**Economic Commission for Europe****Inland Transport Committee****World Forum for Harmonization of Vehicle Regulations****180th session**

**Proposal for Supplement 9 to the 06 series of amendments to  
UN Regulation No. 107 (M<sub>2</sub> and M<sub>3</sub> vehicles)****Submitted by the experts from the Working Party on General Safety\***

## Supplement 9 to the 06 series of amendments to UN Regulation No. 107 (M<sub>2</sub> and M<sub>3</sub> vehicles)

"Figure 31

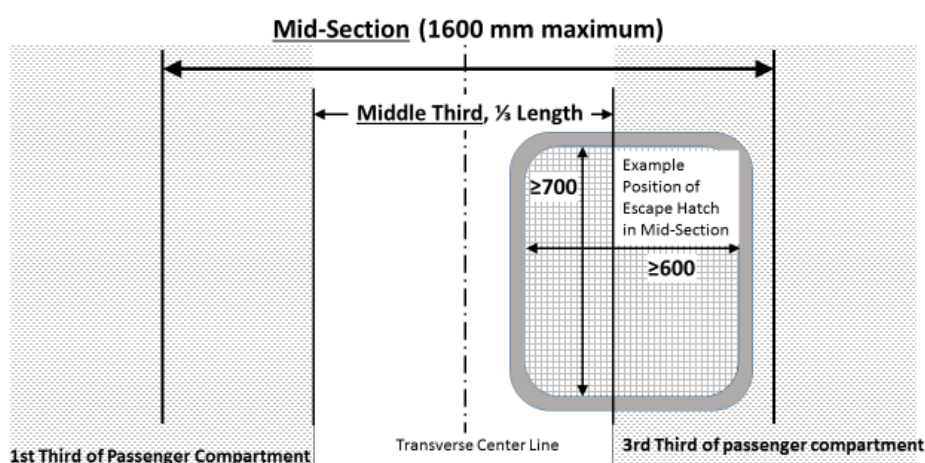
Insert a new Paragraph 7.6.2.9. to read:

"7.6.2.9. For vehicles of classes A and B, required escape hatches shall be positioned as follows:

- (a) If there is only one hatch, it shall be situated in the middle third of the passenger compartment. As an alternative, on vehicles with a very short passenger compartment length, the hatch may be located in the mid-section of this compartment, and this mid-section shall be equally spaced longitudinally each side of the transverse centre line of the passenger compartment, with a length of no greater than 1.6m as shown in Annex 4, Figure 31;
- (b) If there are two hatches, they shall be separated by a distance of at least 2 m measured between the nearest edges of the apertures in a line parallel to the longitudinal axis of the vehicle."

**Alternative placement of escape hatch for very short passenger compartment length having a middle third smaller than 1600 mm**
